SERVICE BULLETIN

Service Bulletin No.: DA20-28-01 Rev 0
Title: Fuel Cap, Safety Chain

Date Issued: August. 26, 1996
Page: 1 of 3

FIGURE 1.

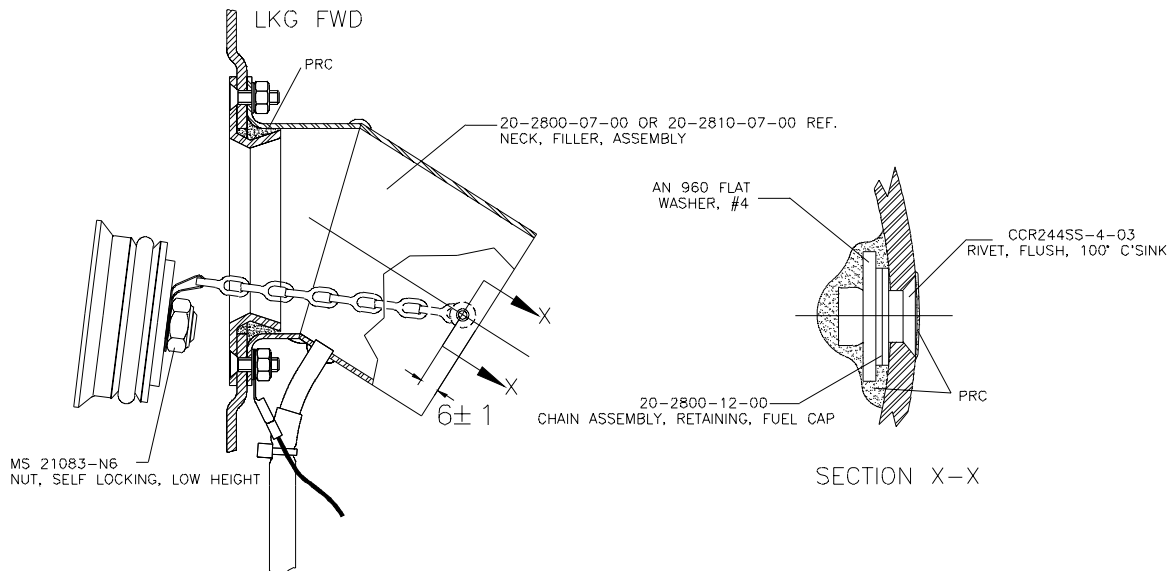
- ### 10.2. Filler Neck Modification:
- 10.2.1 On the aft side of the filler neck (i.e. closest to the B-Bulkhead) drill a .125" / .129" hole in the filler neck shown in Figure 1.
 - 10.2.2 Countersink the .125" / .129" hole so that the rivet will just sit flush to the filler neck O.D. Deburr the hole.

- 10.2.3 Rivet the chain assembly to the filler neck as shown in the section view.
- 10.3 Resealing the Installation:**
 - 10.3.1 Seal rivet with PRC fuel sealant inside and out as shown in section view.
The coating on the filler neck O.D. should be spread flush.
 - 10.3.2 Ensure all grounding straps and vent tubes are properly installed and sealed per the maintenance manual.
 - 10.3.3 Re-install the filler hose apposite to 10.1.2.
 - 10.3.4 Attach fuel cap to chain tab and re-install nut. Nut is in safety when one thread is showing. Note: Inspect nut locking element. If it can be fully finger tightened replace. (ref AC 43.13 1A/2A)
 - 10.3.5 Lubricate fuel cap O-Ring (Fuelube or Vaseline is recommended) and install fuel cap.
 - 10.3.6 Re-install baggage floor
